D206-642-241
Job Sheet 191323

Part Name: Replacement Skidtube, High Gear with Standard Wearplates Fits LH or RH

DRAWING NO. D2650	TITLE 206/407 SKIDTUBE ASSEMBLIES	REV. F	DART AEROSPACE LTD ENGINEERING ORDER		D.E.O. NO. D2650-F-1	SHEET NO. SHEET 1 OF 1	SCALE NTS
DRAWN <i>JP</i>	CHECKED <i>A.P.</i>	MFG. APPR. <i>AA</i>	APPROVED <i>HH</i>		DE APPR. <i>HH</i>		
DATE 12.10.12	DATE 12.10.22	DATE 12.10.22	DATE 12.10.22		DATE 12.10.22

CHANGE C'BORED WELDED CROSSBOLT SPACERS TO SWAGED SPACERS

DETAIL B

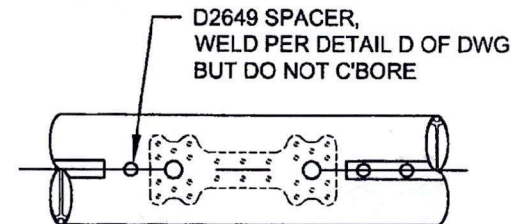
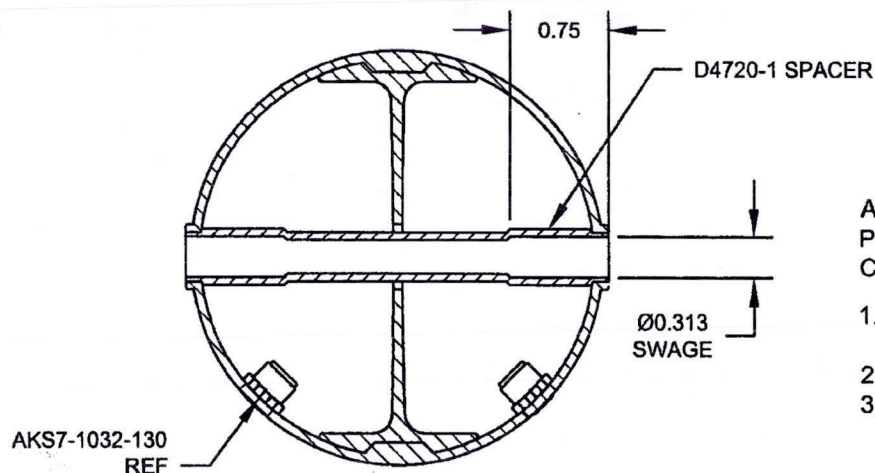
ADD DETAIL G BELOW, WHICH IS THE SAME SECTION VIEW AS DETAIL D OF DWG.

C'BORED HOLES ARE **NOW SWAGED** PER DETAIL G BELOW. FOR THE Ø0.375 HOLE THAT IS NOT C'BORED, WELD PER DETAIL D OF DWG (SEE AMENDED DETAIL B FOR REFERENCE).

QTY	QTY	QTY	QTY	PART NUMBER	DESCRIPTION
-1	-3	-5	-7		
1	1	0	0	D2649	CROSS BOLT SPACER
16	17	19	23	D4720-1	SPACER

17	18	19	23	D2649	CROSS BOLT SPACER
----	----	----	----	-------	-------------------

AFTER DRILLING AND BENDING ASSEMBLY
PERFORM THE FOLLOWING FOR Ø0.375 HOLES THAT ARE
CURRENTLY C'BORED:

1. INSERT D4720-1 SPACER, 16 PL (-1) OR 17 PL (-3)
OR 19 PL (-5) OR 23 PL (-7)
2. SWAGE TO Ø0.313 X 0.75 DP PER QSI 002
3. TRIM / GRIND FLUSH PER QSI 002
